Proposal supplementing document GRSG/2023/16 for Supplement 1 to the 05 Series of Amendments to UN Regulation No. 46 (Devices for indirect vision)

The text reproduced below was prepared by the expert from the International Organization of Motor Vehicle Manufacturers (OICA) to upgrade the proposal introduced by document GRSG/2023/16. The modifications to the proposal contained in that document GRSG/2023/16 are marked in **red bold** characters. The figures are added in the text without any particular colour.

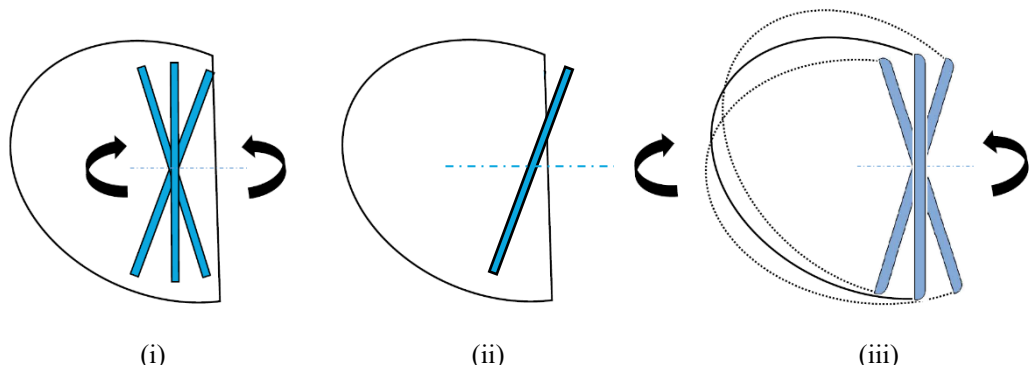
In cases where When the edge of the reflecting surface is enclosed in a protective housing (~~holder, etc.~~), the radius of curvature "c" on ~~it's~~ **the housing's** perimeter shall be not less than 2.5 mm at all points and in all directions, figure below (i).

~~In cases where~~ When ~~If~~ the reflecting surface projects beyond the protective housing in any adjustment position (**figure below (ii)**), the radius of curvature "c" on the edge of the projecting part shall be not less than 2.5 mm and the reflecting surface shall return into the protective housing under a force of 50 N applied to the point of greatest projection, relative to the protective housing, in a horizontal direction, approximately parallel to the longitudinal median plane of the vehicle.

~~In cases where~~ When the edge of the reflecting surface is not enclosed by ~~projects beyond~~ the protective housing independent from any adjustment position, the radius of curvature "c" on its perimeter shall be not less than 2.5 mm at all points and in all directions, and shall apply to the edge of the projecting part, **figure below (iii)**.

(i): Edge of the reflecting surface enclosed in a protective housing

(ii): Reflecting surface projects beyond the protective housing in a specific adjustment position

(iii): Edge of the reflecting surface not enclosed by the protective housing

Figure 1 (a): Traditional outside mirror
Reflecting surface adjusted independently
From the protective housing

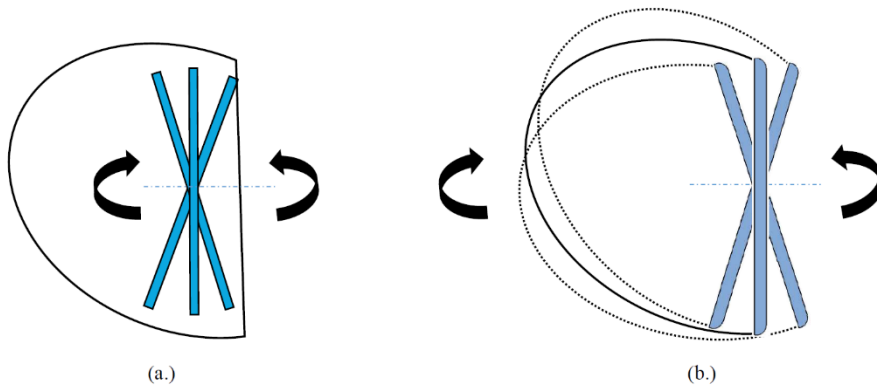
3. For Class II to VII mirrors, it is only possible to have a reflecting surface projecting beyond the housing in single adjustment positions. In this case, the reflecting surface must return into the protective housing if a force of 50 N is applied. This requirement cannot be met by mirrors where the reflecting surface is assembled onto the housing (frameless).

4. A frameless design of the mirror could reduce the width and height of the mirror significantly (up to 30 per cent). This would then have two major benefits: a reduction of collision probability with bicyclists/pedestrians and a reduction of the aerodynamic resistance (c_w).
